HOLDOVER

Revised

BAYOU ISLAND SUBDIVISION

DETAIL SITE PLAN

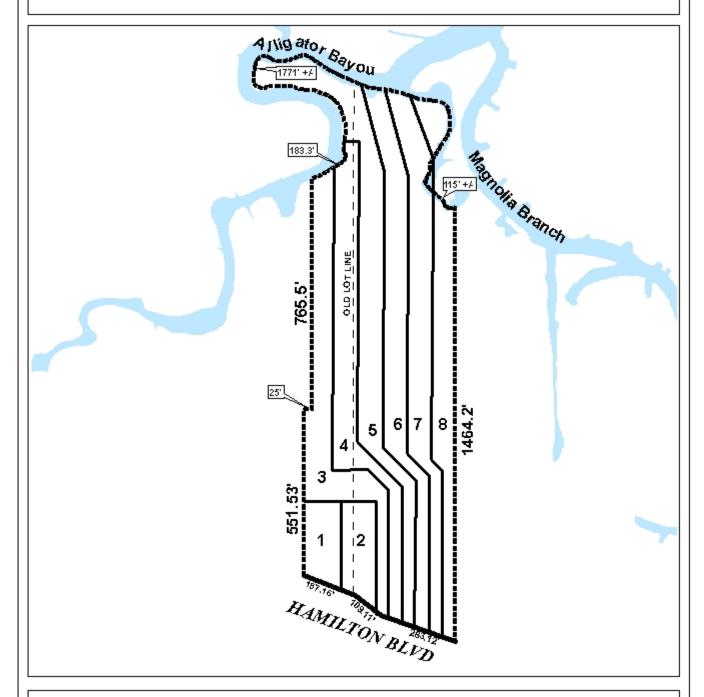
The site fronts Hamilton Boulevard, a planned major street, and the existing right-of-way is shown as variable. The Major Street Plan requires a 100-foot right-of-way; therefore, the dedication of sufficient right-of-way to provide 50-feet from the centerline of Hamilton Boulevard should be required. Additionally, as a means of access management, a note should be placed on the final plat stating that the location, size, and design of all curb cuts are to be approved by County Engineering.

Lots 3 through 8 exceed the maximum width to depth ratio as recommended by the Subdivision Regulations; therefore, a waiver of Section V.D.3., would be required. Narrow, deep lots are typical along waterways; thus a waiver of V.D.3. could be considered appropriate. However, Lots 3 through 8 are only 45-feet wide, and while narrow deep lots are common along waterways, these types of lots typically comply with the minimum width requirements (60-feet wide) as specified in Section V.D.2. of the Subdivision Regulations. Therefore, the lots should be adjusted such that each lot is 60-feet wide.

This application was heldover from the Commission's October 7th meeting until the October 21st meeting to allow the applicant to submit a revised plat illustrating the proposed private drive as referenced by the applicant at the meeting. The staff met with the surveyor regarding options for development, and a private drive is not longer proposed; however, the site should be limited to a maximum of four curb cuts. Additionally, each lot will be 60-feet wide at the building setback line, thus a waiver of Section V.D.2. is not required. However, a note should be placed on the final plat stating that there will be not further Resubdivision of Lots 3-8.

With modifications and a waiver of Section V.D.3., the plat will meet the minimum requirements of the Subdivision Regulations and is recommended for Tentative Approval subject to the following conditions: 1) the dedication of sufficient right-of-way to provide 50' from the centerline of Hamilton Boulevard; 2) the approval of all applicable federal, state and local agencies prior to the issuance of any permits; 3) placement of a note on the final plat stating that the site is limited to four curb cuts; and 4) placement of a note on the final plat stating that there will be no further Resubdivision of Lots 3-8.
